Filename: S04-0138-008

Application firmware revision: 20.0

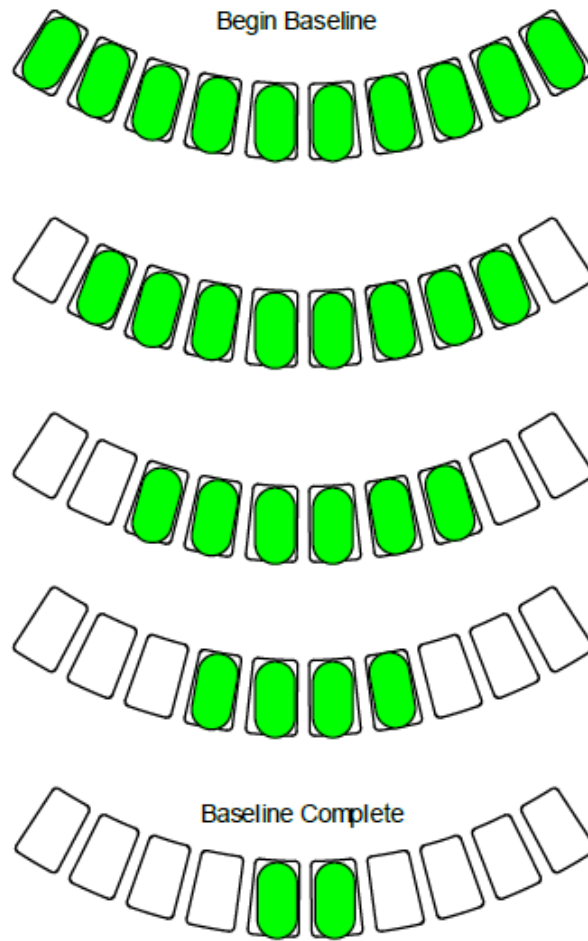
The user interface has been updated to indicate the amount of time remaining during airflow baselining.

If the system has not been baselined or a baseline reset has been initiated the device will illuminate all 10 segments on the airflow graph. As the baseline period progresses the segments will gradually turn off starting from the outside until it reaches the two center segments indicating the device has completed baselining. The baselining period is approximately 5 minutes.

If the device was previously baselined then the two center segments on the airflow graph will blink during the power on initialization period. The power on initialization period is approximately 5 minutes.
